RE: APPROVAL of the Summit Precast 1000 Gallon Two Compartment Concrete Septic Tank for use in Wyoming.

RE: Summit Precast Septic Tank - Loading

SUMMIT PRECAST
1000 GALLON SEPTIC TANK

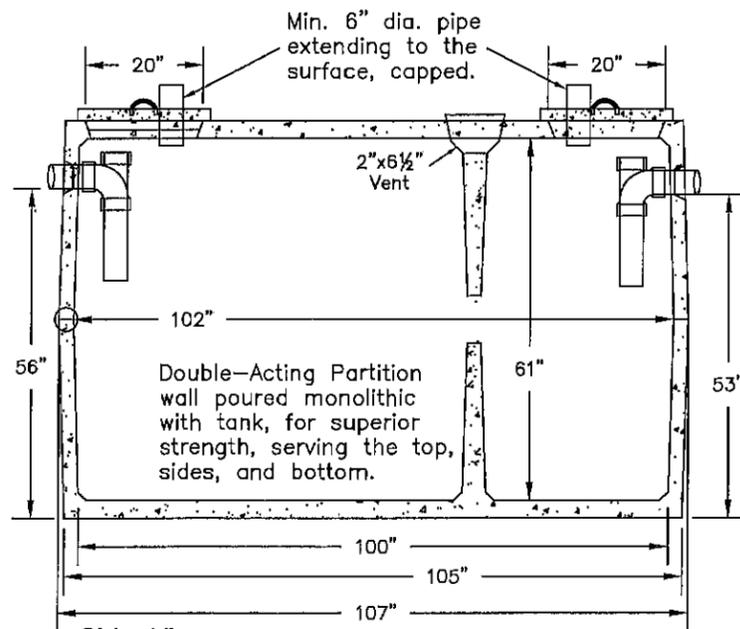
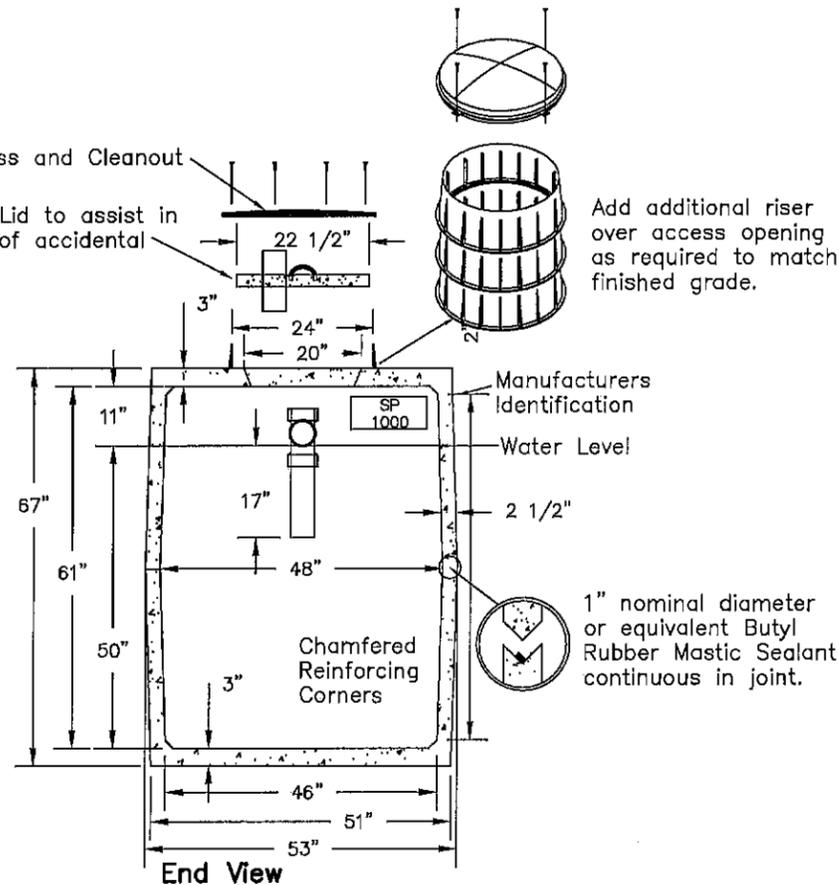
The Water Quality Division (WQD) of the Wyoming Department of Environmental Quality (DEQ) has received and reviewed the specifications for your 1000 gallon two compartment concrete septic tank. The WQD finds that this septic tank design meets the minimum requirements as identified in Chapter 11, Section 39 of the Wyoming Water Quality Rules and Regulations. Subsequently, this product will be placed on our "A-List" of approved septic tanks for use in Wyoming.

WLC has performed calculations to determine the loading specifications for the **Summit Precast 1000 Gallon Septic Tank** as seen in drawing #14539 Sheet 1 of 1.

Using 4000 psi concrete, based on the lid dimensions of 107" x 53" x 3" and including reinforcing 6" x 6" x 10 gauge wire mesh located 2" from top and sides of lid, we have concluded the following. The **maximum recommended bury depth for the tank is 48" (4'-0)**.
